January 11, 2000

The Honorable Richard A. Meserve
Chairman
U.S. Nuclear Regulatory Commission
Washington, D.C. 20555-0001

SUBJECT: COMMENTS ON THE IMPORTANCE OF CHEMISTRY IN THE NEAR FIELD
TO DOE's YUCCA MOUNTAIN REPOSITORY LICENSE APPLICATION

CHEMISTRY IN THE PROPOSED YUCCA MOUNTAIN REPOSITORY NEAR FIELD

Figure 1. Waste Package and Drift Design Cross Section

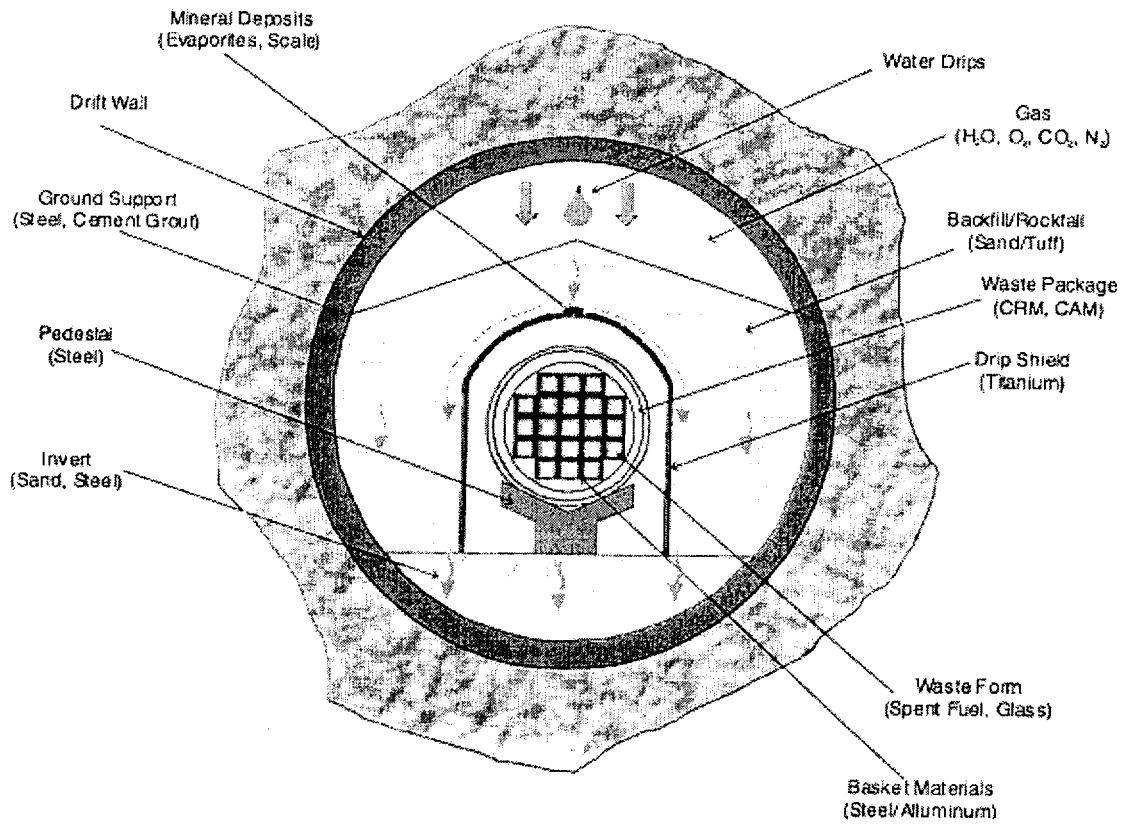
The current waste package design is shown in cross section Figure 1. The outer container has a 2 centimeter-thick wall of alloy C-22, whose composition is given in table 3. The inner container has a 5 centimeter-thick wall of stainless steel. It is expected that the stainless steel will corrode much faster than the C-22 once water breaches the C-22, and that in times far shorter than the repository licensing period it will be completely oxidized provided that the C-22 is in fact breached. As noted above, this steel could produce locally reducing conditions in the waste package or drift, and if oxidized, will add to the ionic iron content of the water. (Iron corrosion products would occupy more volume than the stainless steel from which they come, leading to potential adverse mechanical and structural effects. However, these effects are not considered here.) Unlike the steel in the waste package support and the steel invert, the iron ions from the stainless steel in the waste package container will be available for chemical reactions with the waste form itself at the water-waste interface.
